PLANNING COMMISSION MEETING
Tuesday, January 12, 2016
6:30 p.m.
Council Chambers
2nd Floor City Hall
1300 NE Village Street

1. Application 2015-60-MOD. This application is for a major modification to an approved land use decision #03-49-DR-SEC. This modification includes site redesign and proposed construction of 10 new mini-storage buildings and 3 new RV/carport buildings totaling 183,864 sq. ft.

PLANNING COMMISSION STAFF REPORT
EXHIBIT "A" FINDINGS OF FACT

Staff Contact:	Erika Palmer, Development Analyst
Public Hearing Date:	January 12, 2016
Date of Report:	January 5, 2016
Application Number:	2015-60-MOD
Application Deemed Complete:	November 20, 2015
120 Days Application Decision Date:	March 19, 2016
Exhibits:	A. Findings of Fact B. Referral Comments
Attachments:	1. Vicinity Map 2. Site Plan 3. Grading Plan 4. Utility Plan 5. Landscaping Plan 6. Elevations
Application/Proposal:	A request to consider a modification to an existing design review (application number 03-49-DR/SEC) to reconfigure the site design and the installation of 10 additional mini-storage buildings and 3 RV/Carport buildings totaling 104,690 square feet.
Applicant:	Brad Fudge ALL-STOR Storage, LLC 20918 NE Sa

DATE	JULY, 2011
SCALE: AS NOTED	PROJ. NO: 209291
DRAWN: CJM	CHECKED: JTR
SHEET NO: G1.0

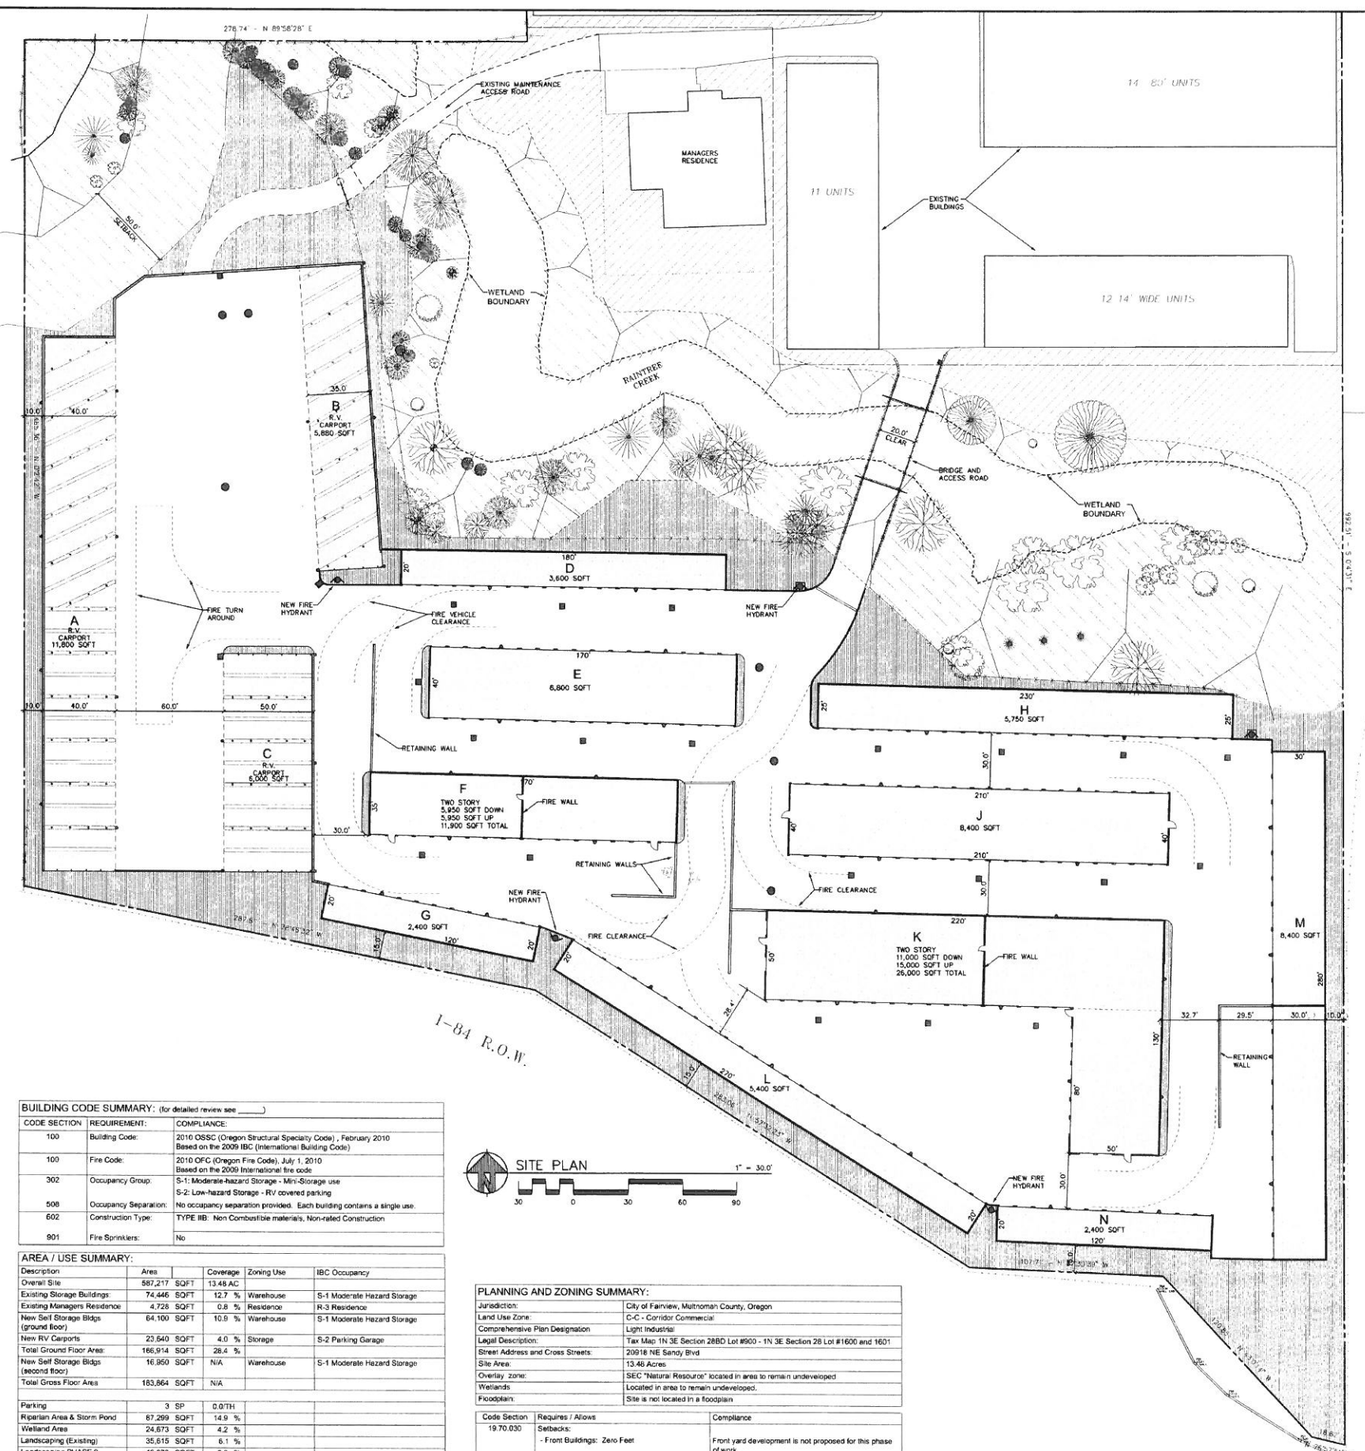
3. No Parking Fire Lane signs or curb marking will be required on site. The marking will be indicated on the building permit plans. OFC App D-103.6

4. The turning radius for all emergency apparatus roads shall be 28' inside and 48' outside radius. The building permit submittal set will need to show the radiuses on the site plans. OFC 503.2.4

9. All on site drives are considered fire access roads. Gresham Fire requires the access roads support a 75,000 lb. imposed load. Provide an engineer's letter stating that the requirements are met at time of building permit submittal. OFC App. D – 102.1
